***Board of Zoning Appeals Public Hearing
September 20, 2016 — 7:00 P.M***

CASE NUMBER:	V-16-019
PROPERTY LOCATION:	11020 Bell Road, Johns Creek, GA 30024 1st District, 1st Section, Land Lot 461
CURRENT ZONING:	AG-1 (Agricultural)
PARCEL SIZE:	7.84 Acres
PROPERTY OWNERS:	Dr. Chalam Mahdevan
STAFF RECOMMENDATION:	PARTIAL APPROVAL

Figure 2. Alternative location, which is outside of the stream buffer, for the proposed garage is shown in red. Yellow line represents 75-foot no impervious surface setback line.

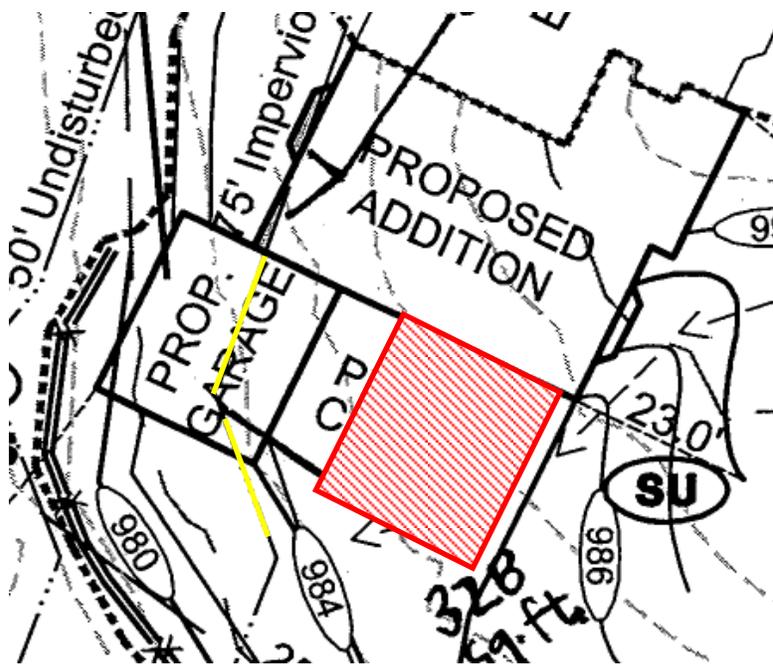
Two clear alternative locations exist for the garage that would allow for the expansion of the home, while respecting the current stream buffer requirements. One alternative location would be to push the proposed

garage forward so that it is more in line with the front of the proposed master bedroom/living space addition (figure 2). Another alternative would be to locate the proposed garage on the other side of the house, where the existing driveway is located (figure 3).

- 1) That the addition shall be limited to no more than 23-square feet of new impervious within the 75-foot no impervious surface setback, as shown on the site plan received on August 30, 2016.
- 2) That the proposed garage addition cannot be constructed within the 75-foot no impervious surface setback.
- 3) The applicant is required, prior to issuance of a certificate of completion, to replant vegetation on the subject property to offset any adverse impact associated with the additional disturbance/impervious surface closer to the stream. A new mitigation plan shall be submitted for review by the City Arborist that mitigates the smaller encroachment of 23-square feet.
- 4) Obtain required building permits from the City of Johns Creek Community Development Department prior to commencement of construction.
- 5) Building materials and architectural style shall match existing residence.
